# Lyons Avenue/Dockweiler Drive Extension Project Final Environmental Impact Report

Lead Agency:  
**City of Santa Clarita**  
23920 Valencia Blvd., Ste. 302  
Santa Clarita, CA 91355  
Contact: Carla Callahan, Senior Engineer

**February 2018**

Figure 6.1-4  
 Market Street Alignment Plan and Profile

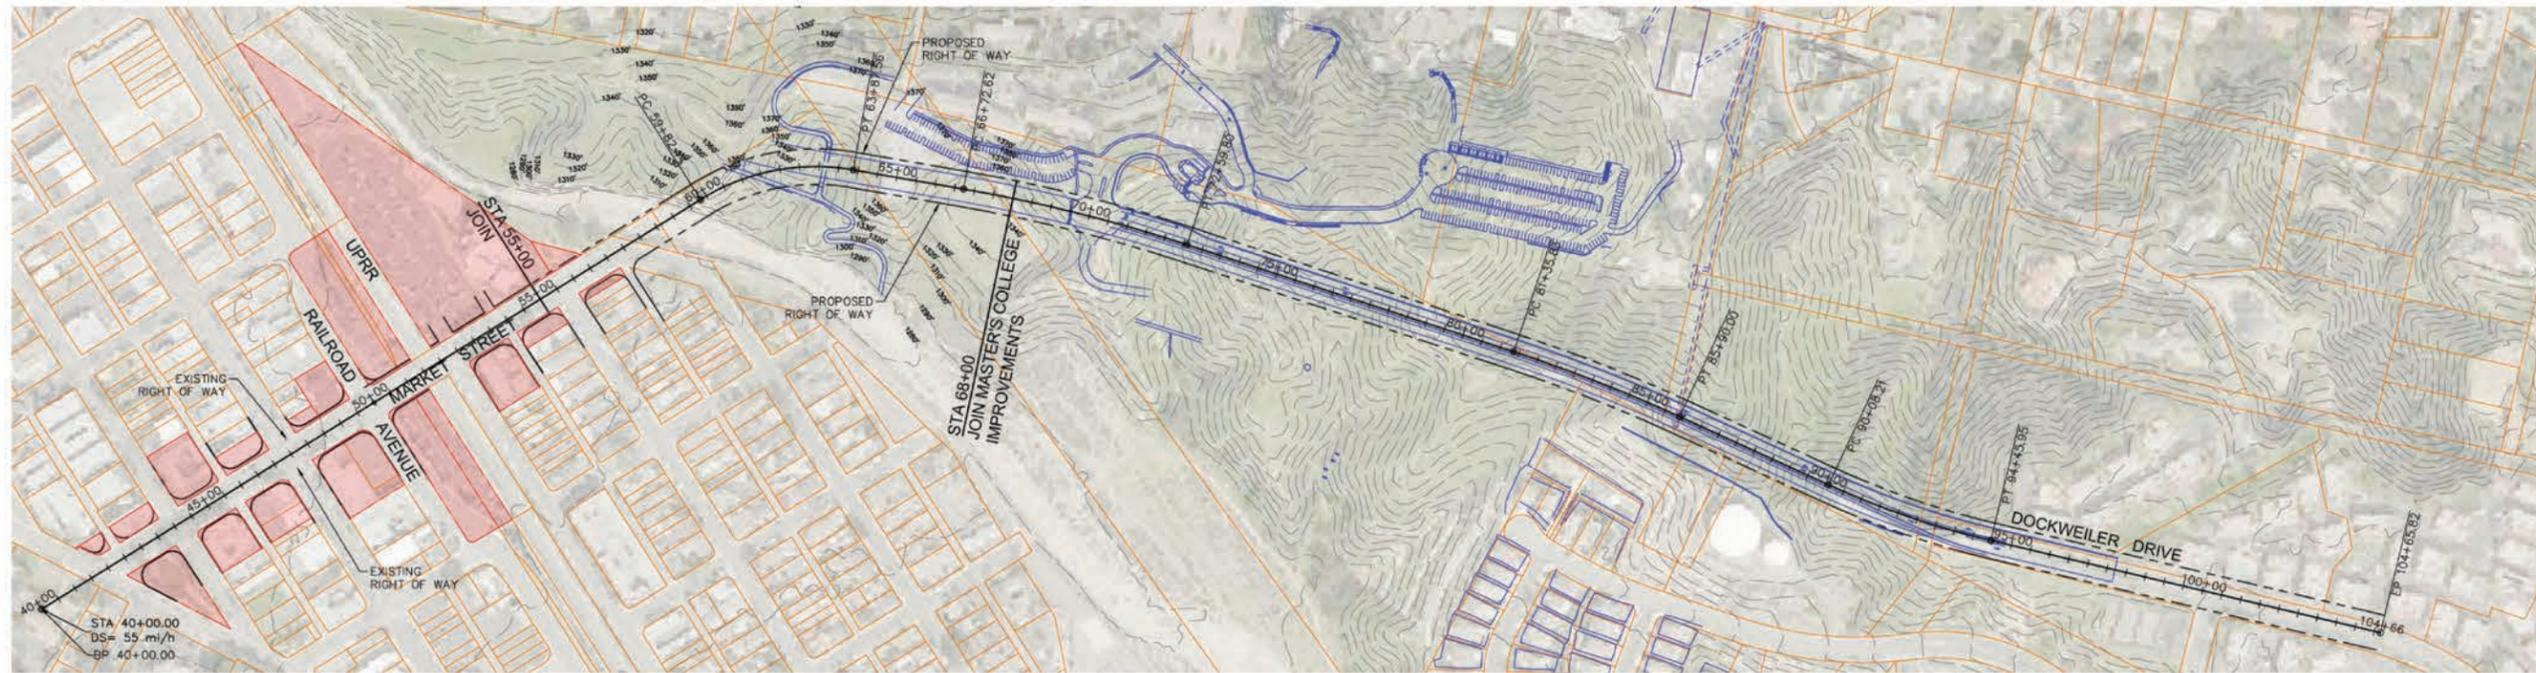
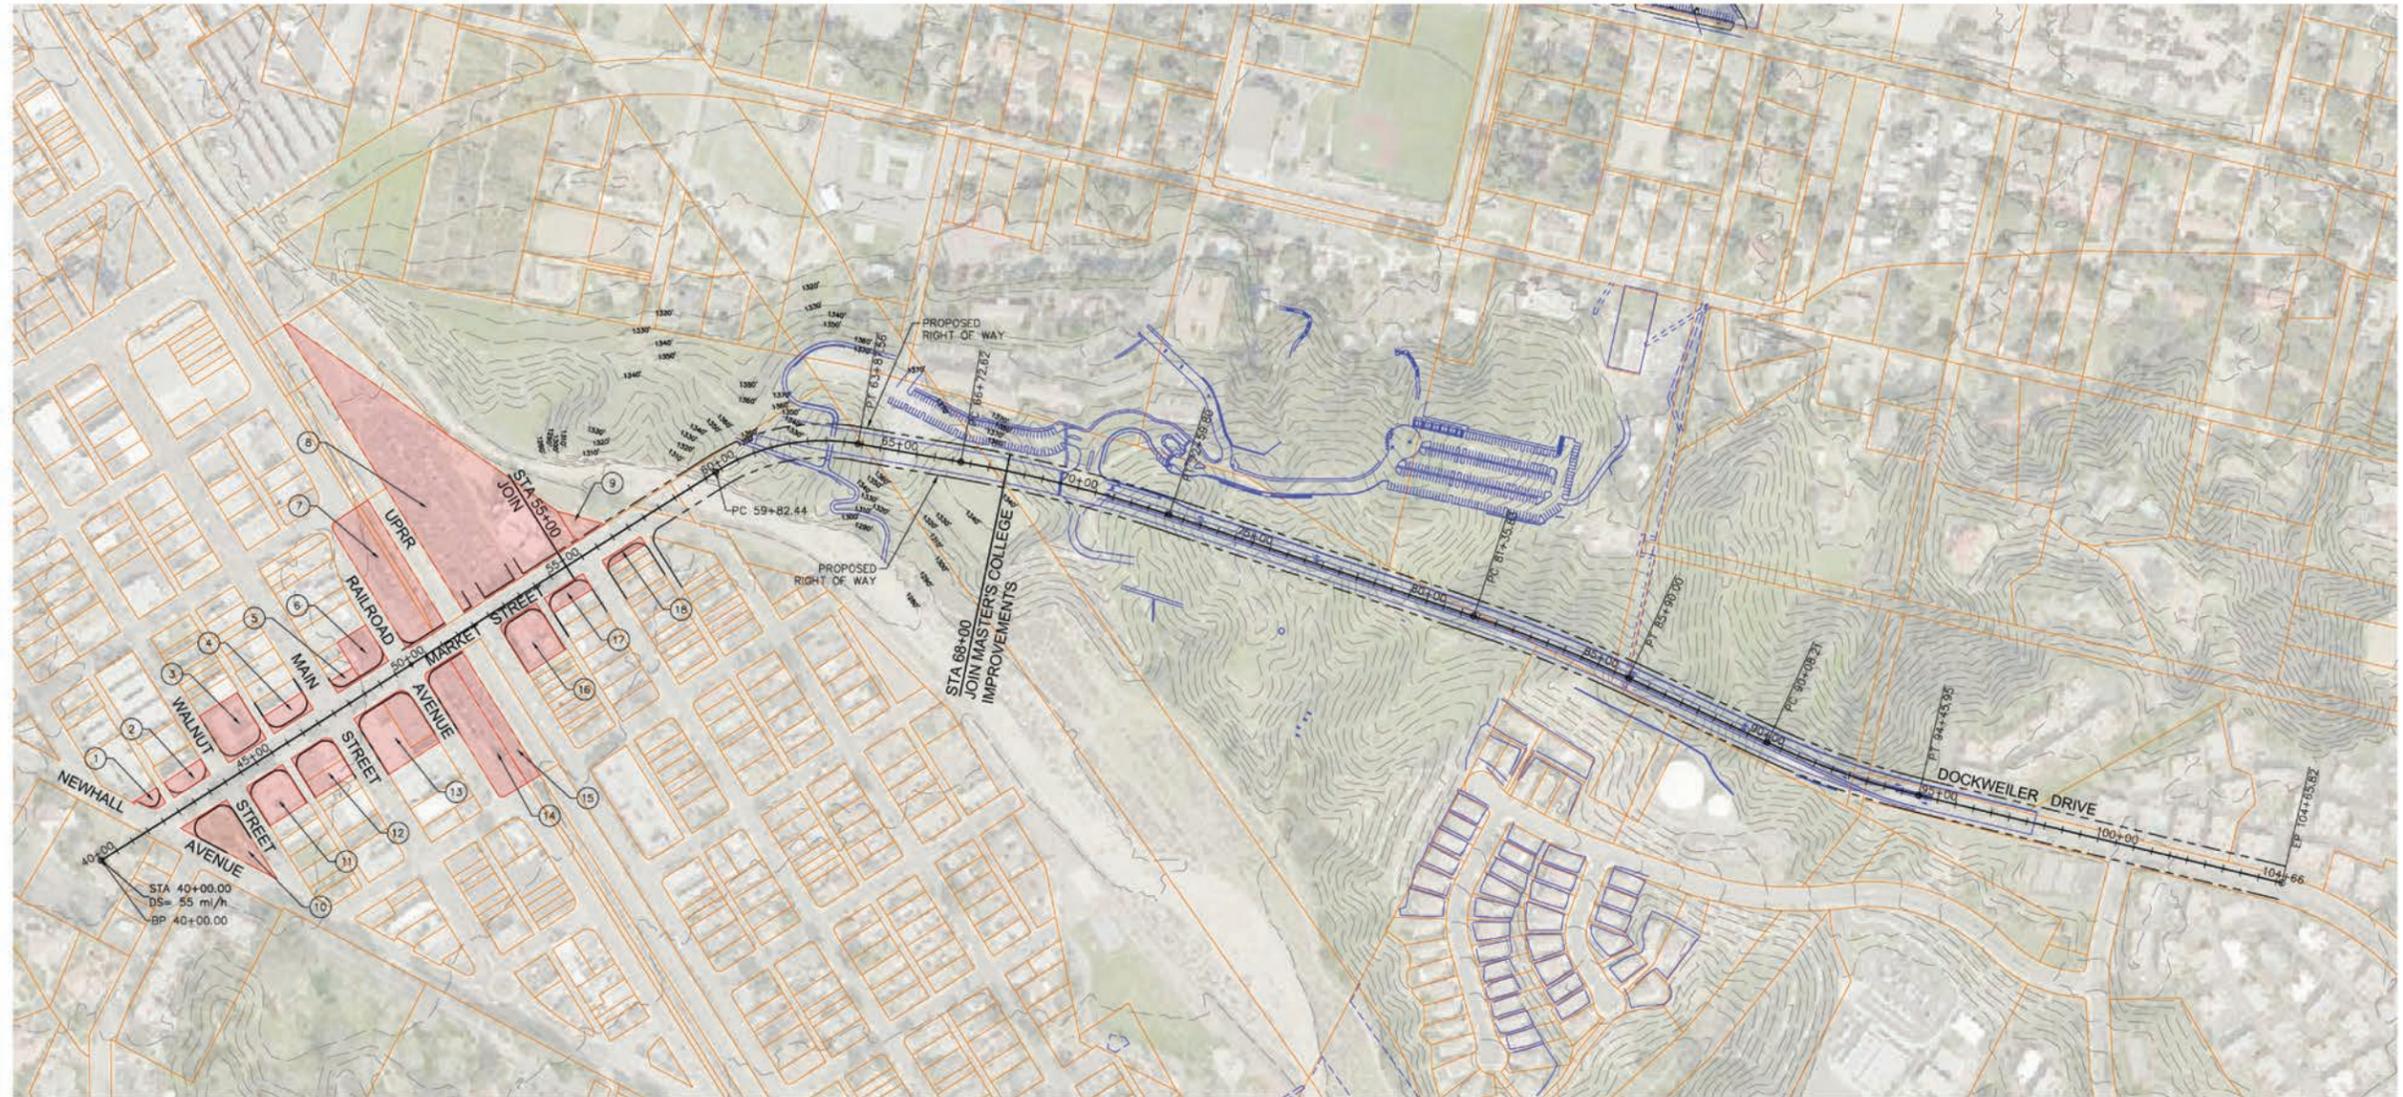
On page Figure 6-1-1 Market Street alignment if 1350 @ 58+00 why stop at 75+00 and not take it out to 104+66 and it would be under 1500 that is less then .6%. at points 85+00 Lower Master's point and draw a straight line it does go approx. 1480 vertical at 104+66. I not an engineer but please look at it. [sic]

In order for Dockweiler Drive to connect to Market Street and maintain a 6% profile, to comply with roadway standards for secondary highways, the join point on this profile would need to encroach on private property to connect to the terminus of existing Dockweiler Drive, which would conflict with the approved Masters University entitlements and site development design for the portion of the Dockweiler Drive extension that was approved in 2009. Such an alignment would necessitate a complete design change to the Masters University roadway plan, and may result in a change or revocation of the approved Master's University entitlements.

Additionally, as shown in Figure 6.1-4 Market Street Alignment Plan and Profile and Figure 6.1-5, Market Street Alignment Geometric Plan, the proposed Dockweiler Drive extension would require a 92' right-of-way for Market Street from the crossing at Newhall Creek to Newhall Avenue to comply with roadway standards for secondary highways. Market Street is currently designated as a collector street with two through lanes and on-street parking. With the proposed 92-foot right-of-way, approximately 17 parcels (approximately 0.49 acres) on Market Street would require partial acquisition as well as improvements to the railroad crossing to facilitate the wider right-of-way and roadway improvements. The acquisition of parcels would include the Newhall Metrolink station and the City of Santa Clarita Newhall Community Center located on the north side of Market Street, residential properties on the south side of Market Street, the Veteran Memorial Plaza at the intersection of Newhall Avenue and Market Street, and additional land at the at-grade railroad crossing at Market Street. Additionally, commercial and residential properties and parking facilities along the north side and south side of Market Street west of Railroad Avenue would be acquired to accommodate the 92' right-of-way.
